RECEIPT DATE: 3/4/22 **ONSITE SEWAGE DISPOSAL SYSTEM**

PROPERTY ADDRESS: 5517 Jacks Landing Way Clarksville, MD 21144

**RE: OSDS Plan**  
**Jacks Landing Phase II, Lot 6**  
**5517 Jacks Landing Way**

**ONSITE SEWAGE DISPOSAL SYSTEM DESIGN PLAN**  
JACK'S LANDING, PHASE II  
**LOT 6**  
PLAT No. 25063  
5517 JACKS LANDING WAY, CLARKSVILLE  
TAX MAP 34, GRID 3, PARCEL 414  
5TH ELECTION DISTRICT HOWARD COUNTY, MARYLAND  
SCALE: 1" = 20' JOB NO.: 3438 DATE: DEC. 5, 2020 SHEET: 1 OF 1

JACK LANDING LOT # 6 RO TRENCH AS BUILT

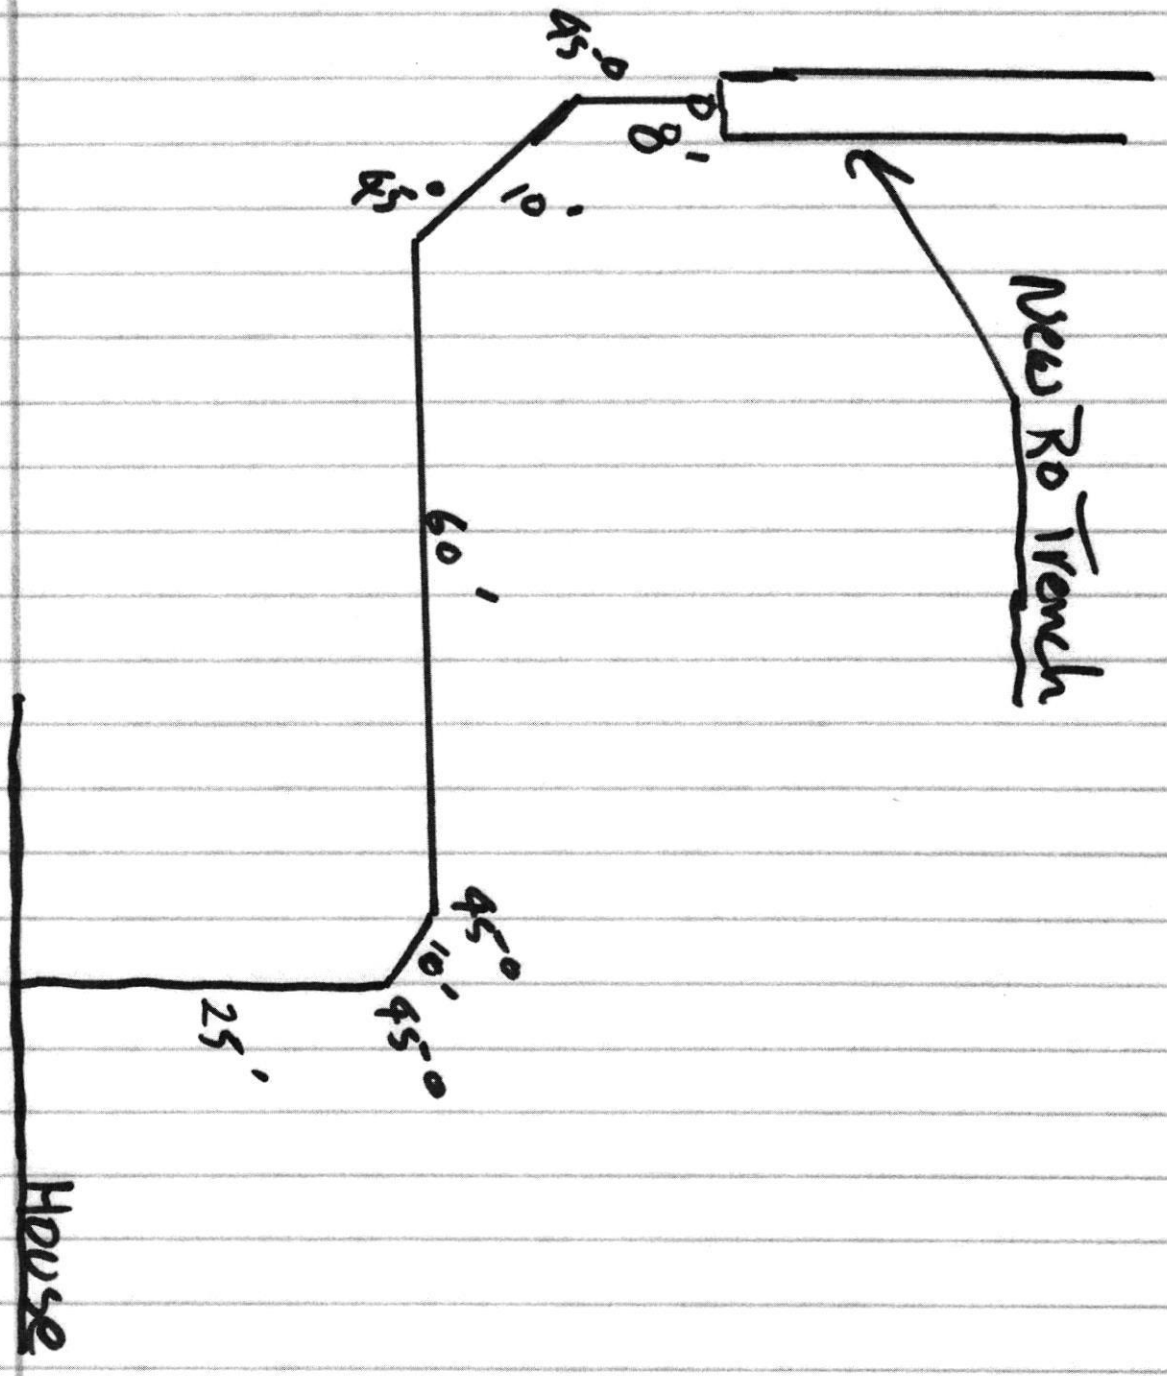
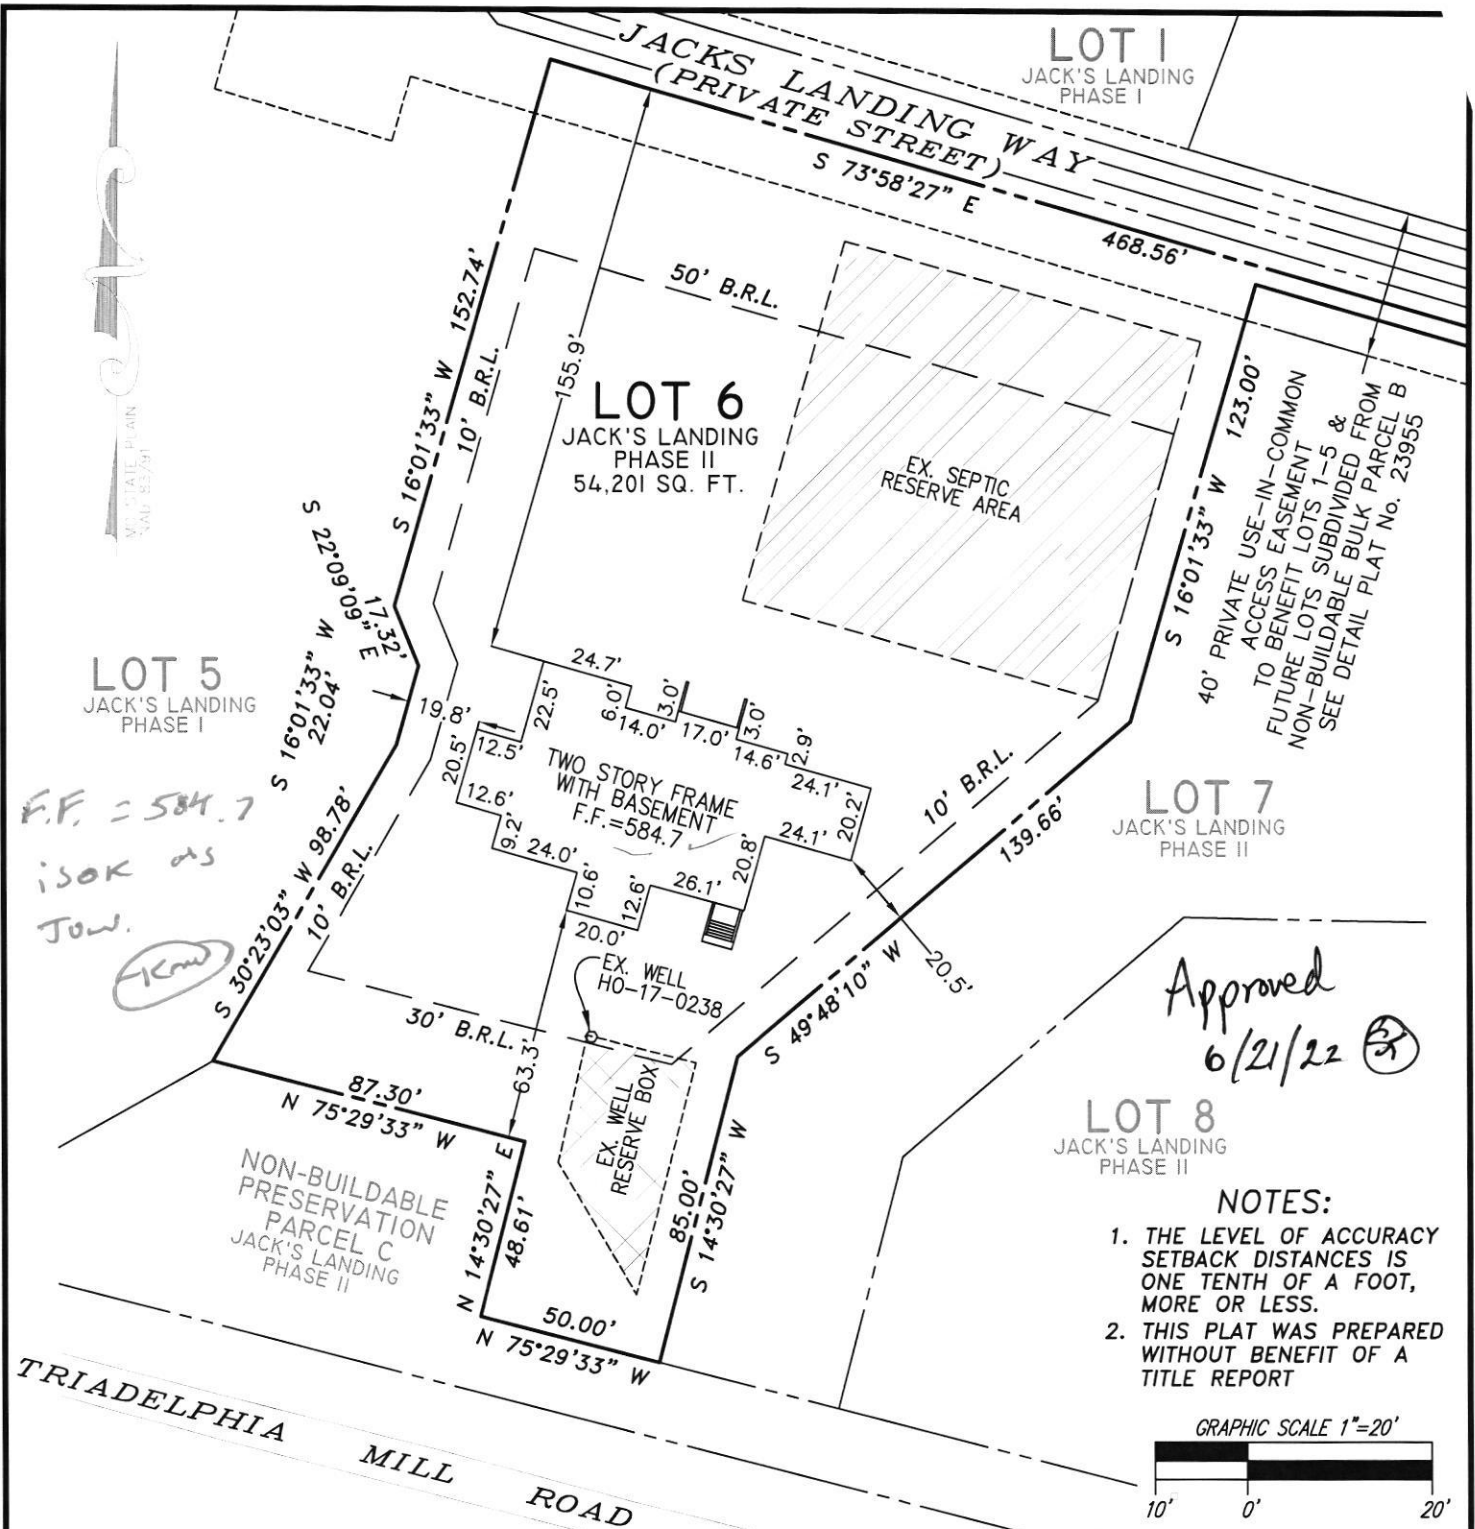
9/28/22 - Site inspection for open R/O trench. 4' x 105', 8' deep, contractor did not have most recent approved OSDS plan and dug the trench for the R/O line into the house in the wrong location ok to continue. - reinspect R/O trench for stone, fabric & inlet and perforated pipe, line from house not constructed yet, sewer line already backfilled w/ c/o on the inside of the house, will add approximately where the sewer line is on the AS-Built. (KM)

Jeff and I reviewed the file and we have an option that should be suitable for the location of the ro trench. Looking at the osds plan, our option is to relocate the trench above the existing trenches just installed for the house main septic. We know it will be out of the sda but with the limited area available due to the fill, we really do not have many other options. This location will also be within the well box setback for lot 5 and this ok and we will be adding a memo in with this lot file to reflect this (Lot 5 has other area for future well replacement). The only thing with this location is the loading rates are slightly slower in this area and will make the RO trench design a lot larger, @ a 1.07gpd/sq ft instead of the 1.6gpd/sq ft. For this, instead of a 3ft wide trench, MDE has allowed the RO discharge trench to be 4ft with exceptions. Let's design it as 4ft wide which should ultimately keep it the same length as initially proposed (100ft). Try to place the trench as best on contour as possible while maintaining 10ft min off the trenches. I think we are assuming that the RO system proposed in the house will stretch its limit's to 1:1 or better, at least that's what has been said. Let me know if you have any questions on this. I'd be happy to discuss in person if there are any questions or concerns. Please show this design on the revised osds plan. Note that unless we re-route the RO discharge line out of the house, there will be a crossing at the main 4' sewer house connection.

9/27/2022 Revised OSDS approved, reflects new location of RO trench. (KM)

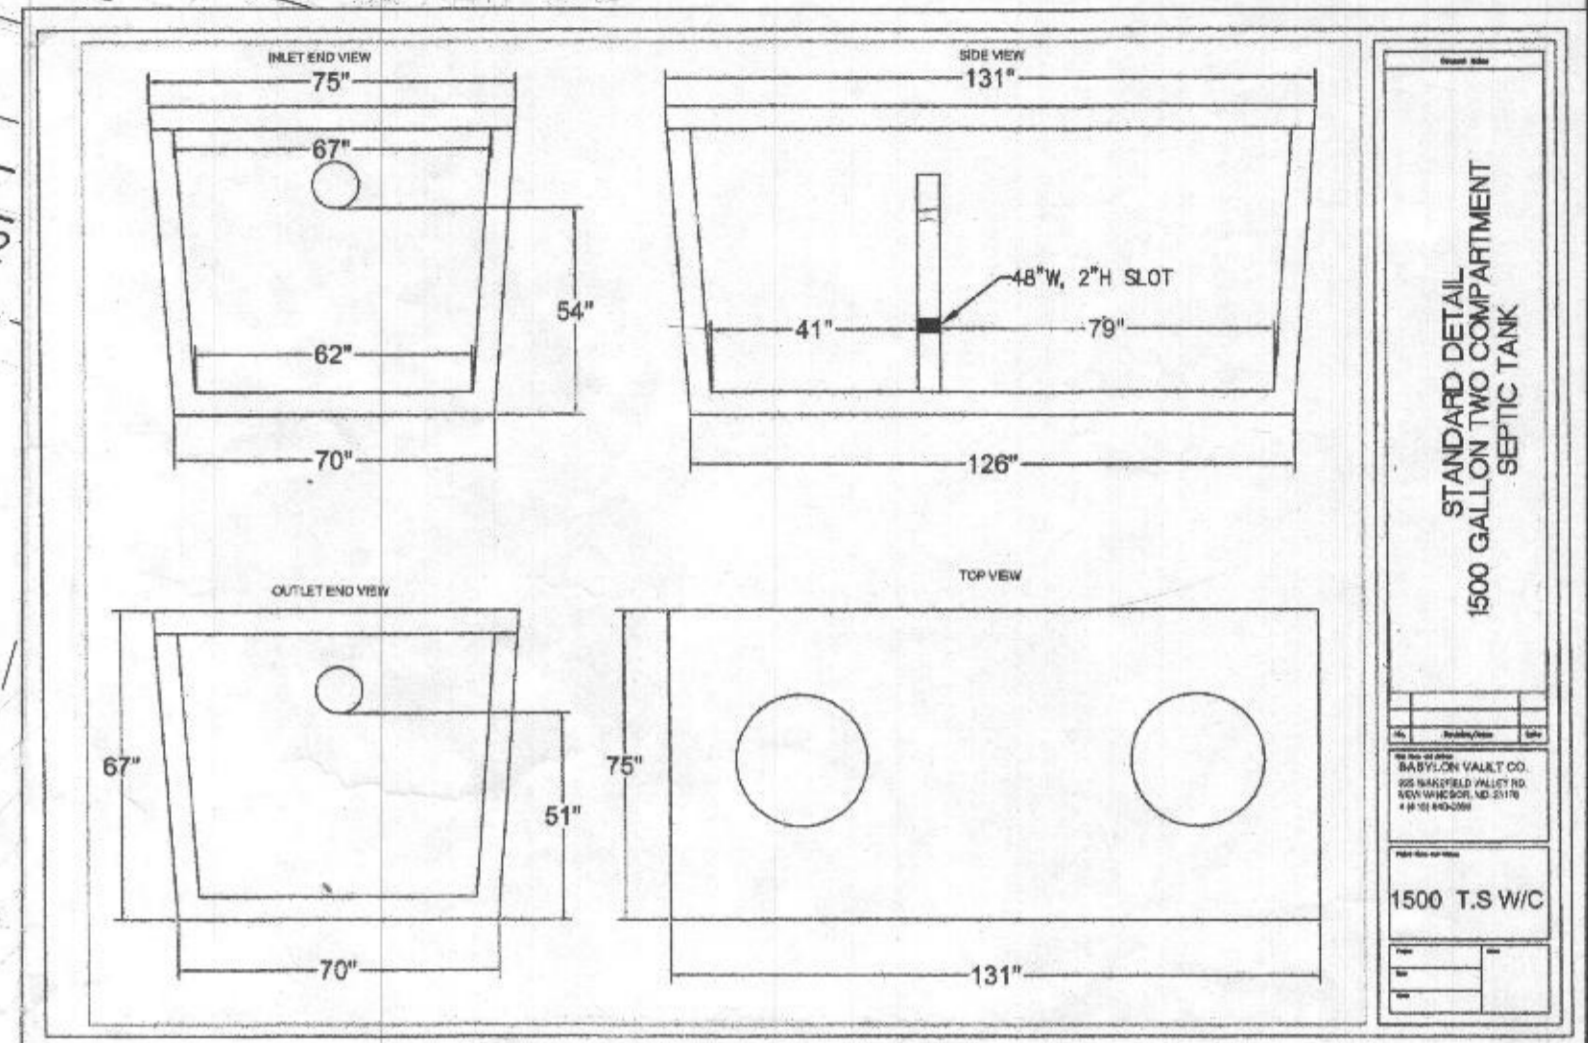
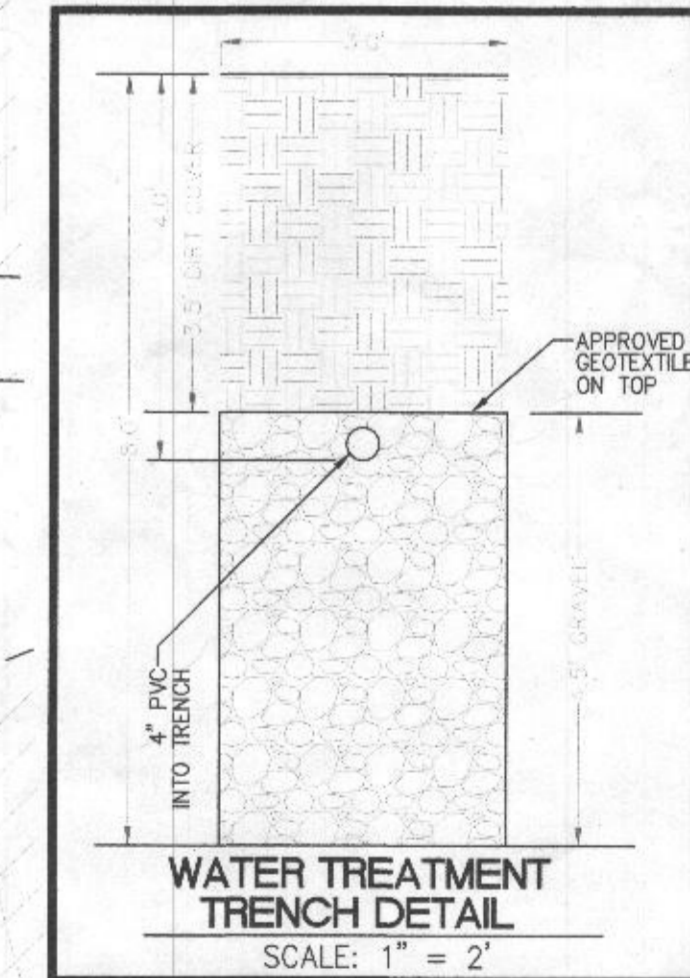
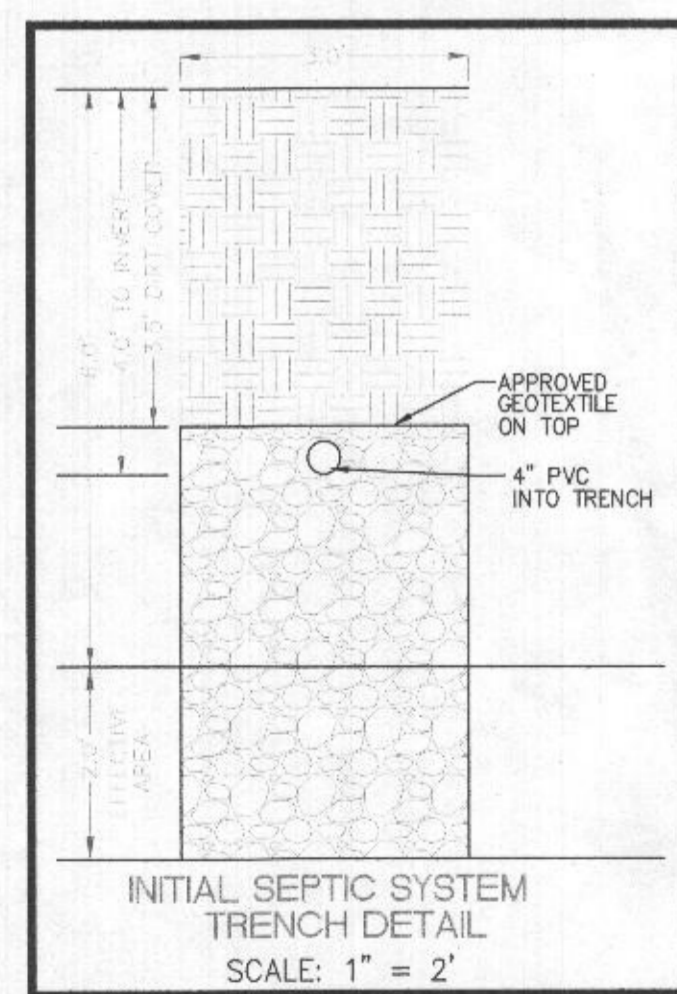
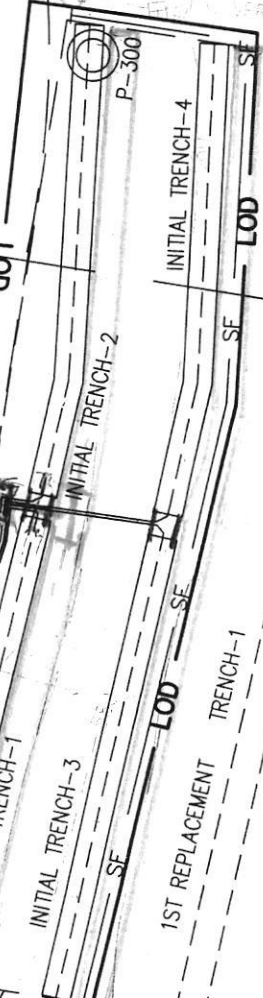
I am little concern about the lack of fall from the d-box to the ends of the trenches (0.65%). I recommend keeping the d-box where it is and splitting each trench in the middle and center feeding them. Is there enough room?

- I don't love the layout - they can lower the trench a bit to get better fall

- 1.) Move tank out of SDA
- 2.) Place initial system at top of SDA and move water treatment to bottom of SDA and use 1- 100 ft. trench.
- 3.) Maintain 25 feet from bio retention pond to SDA.
- 4.) Maintain 25 feet from pond discharge pipe to SDA.

As per the attached revised plan, four 49' trenches can fit with a slope of over 1.5% from the box to trench 1 and 2 and 2.5' space from end to end. Please let me know if this is the only comment and it's addressed, I will drop off prints of the attached tomorrow.

- 1- The tank is moved outside the SDA and placed in the gap between the SDA and the Well Box 100' radius.
- 2- The initial system and the Water Treatment trenches are moved as directed.
- 3- The SWM pond is placed at a minimum distance of 25' distance from SDA and noted as such on the plan.
- 4- The location of the outfall of the SWM facility that is shown for this project is the only feasible spot on this lot due to height restriction. This location is within an existing Storm Water Management device (Swale with Check Dams) and it is already in violation of the 25' setback to the SDA. Further, we directed the flow of the pipe away from the SDA and we are proposing to protect the area with outfall protection Riprap. An approval of this location is essential for a building on this lot.
